ATTACHMENT 2
NRC DOCKET 50-321
OPERATING LICENSE DPR-57
EDWIN I. HATCH NUCLEAR PLANT UNIT 1
ADMINISTRATIVE TECHNICAL SPECIFICATIONS SUBMITTAL

The proposed change to the Technical Specification (Appendix A to the Operating License) would be incorporated as follows:

ATTACHMENT 3
NRC DOCKET 50-366
OPERATING LICENSE NPF-5
EDWIN I. HATCH NUCLEAR PLANT UNIT 2
ADMINISTRATIVE TECHNICAL SPECIFICATIONS SUBMITTAL

FIGURE 6.2.1-1 OFFSITE ORGANIZATION

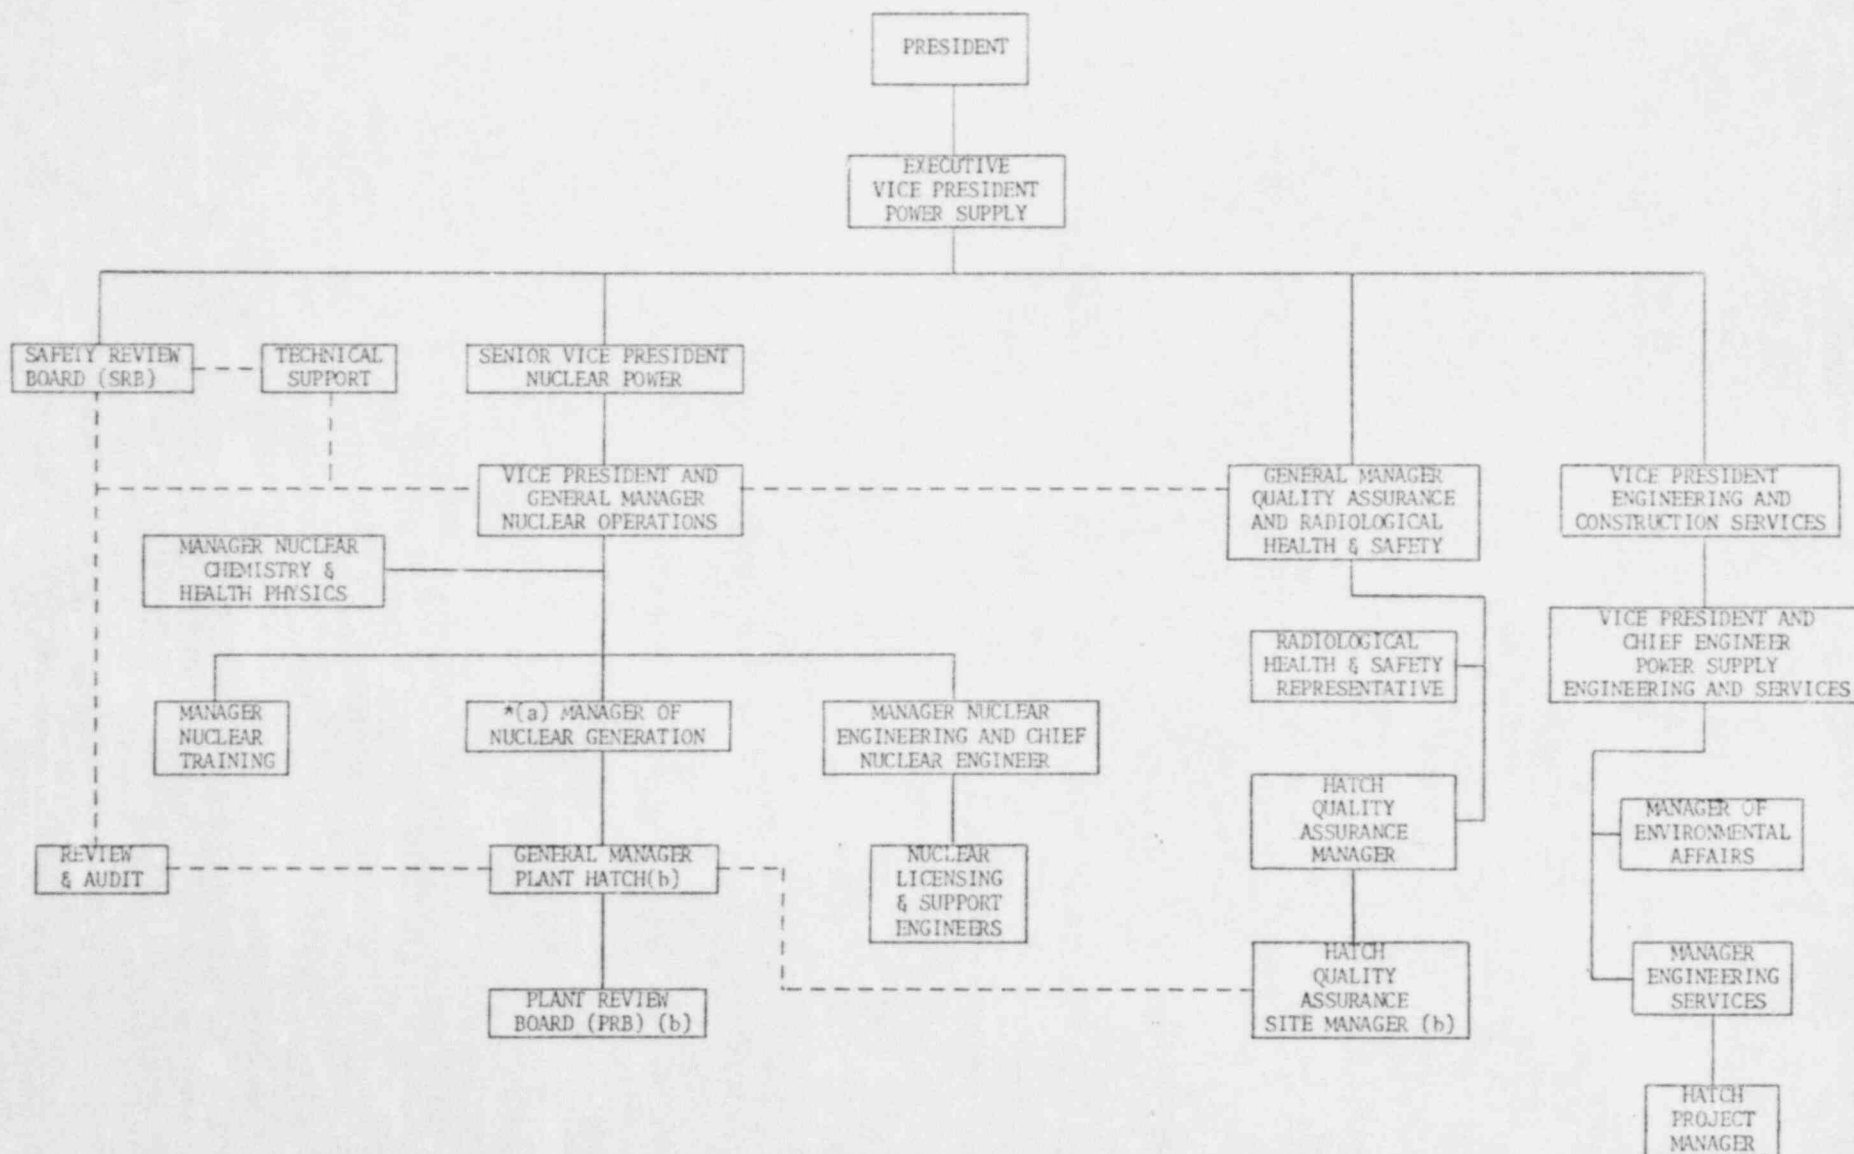
* CORPORATE RESPONSIBILITY FOR FIRE PROTECTION
 a CURRENTLY VACANT
 b ONSITE PERSONNEL

FIGURE 6.2.1-1 OFFSITE ORGANIZATION

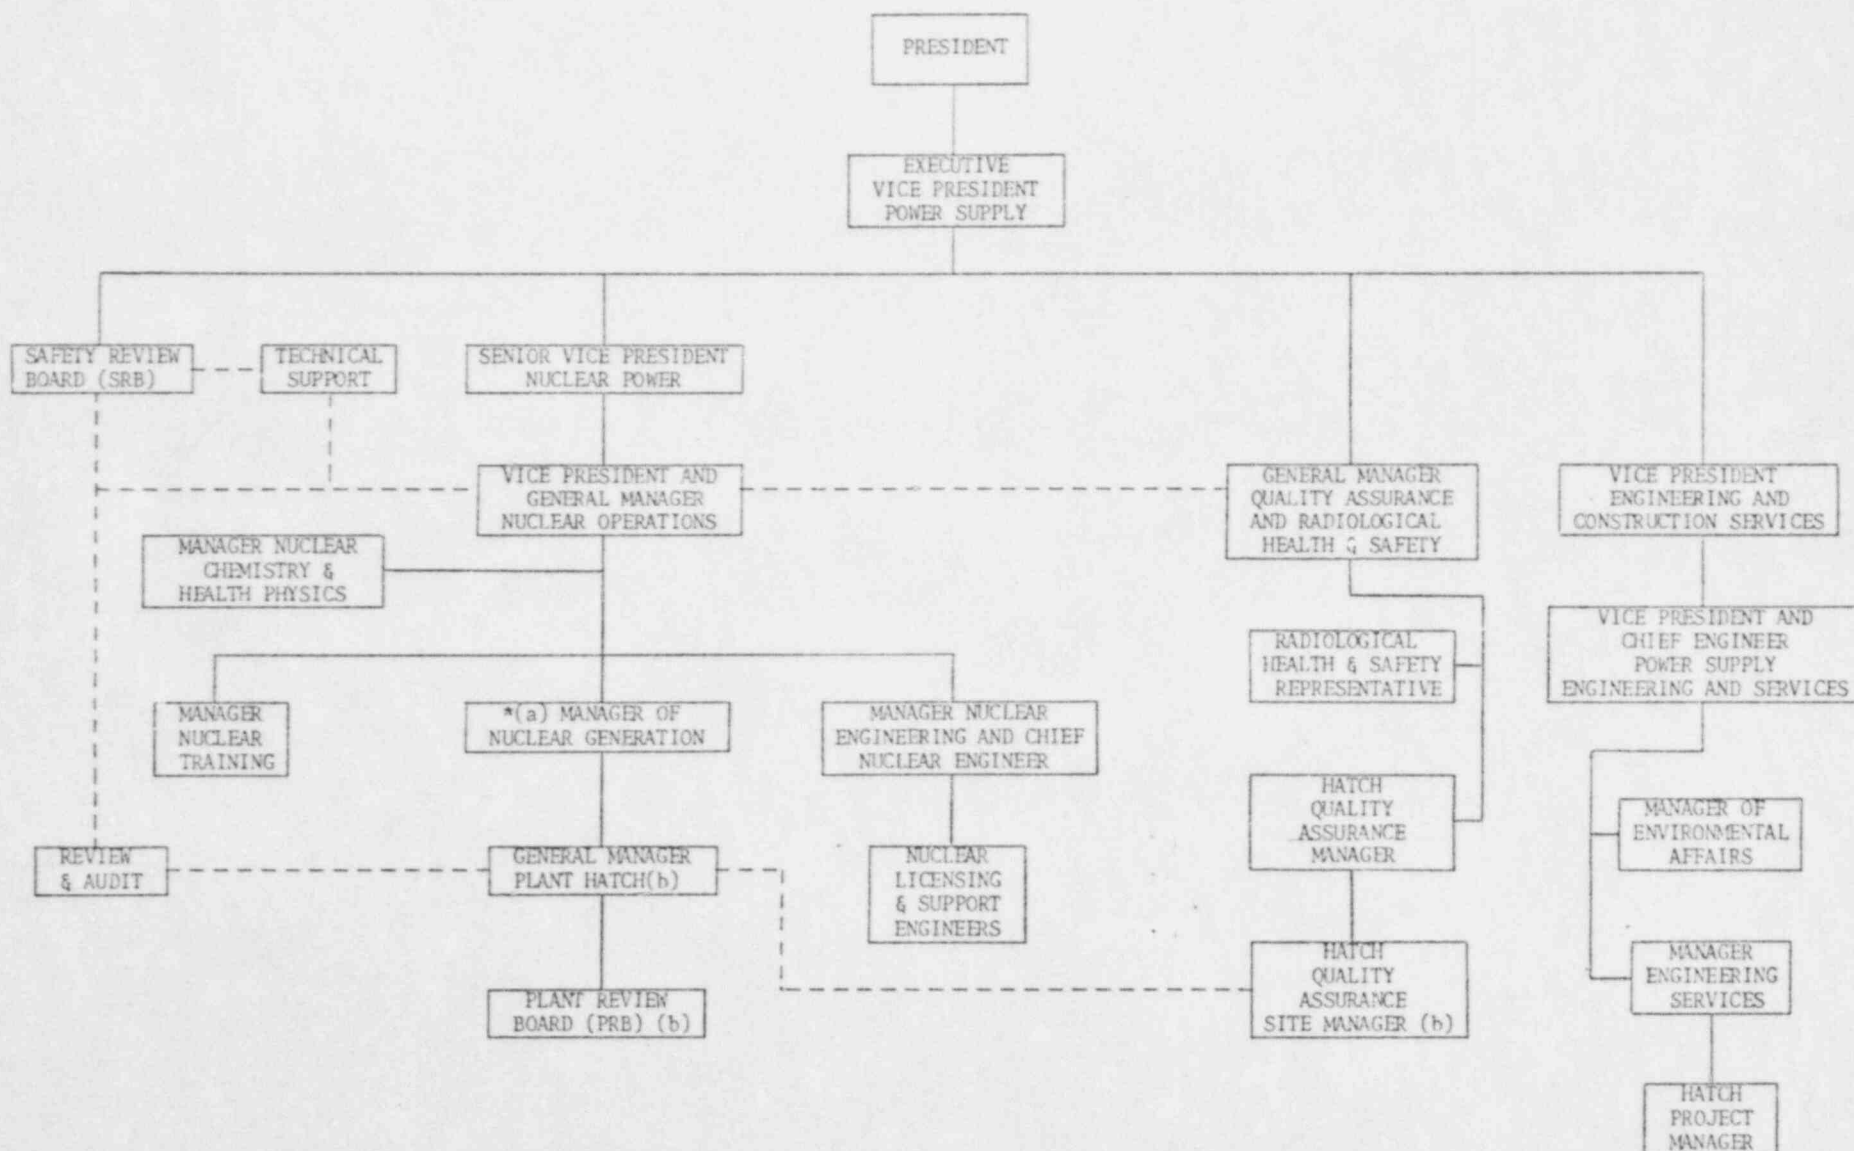
* CORPORATE RESPONSIBILITY FOR FIRE PROTECTION
 a CURRENTLY VACANT
 b ONSITE PERSONNEL
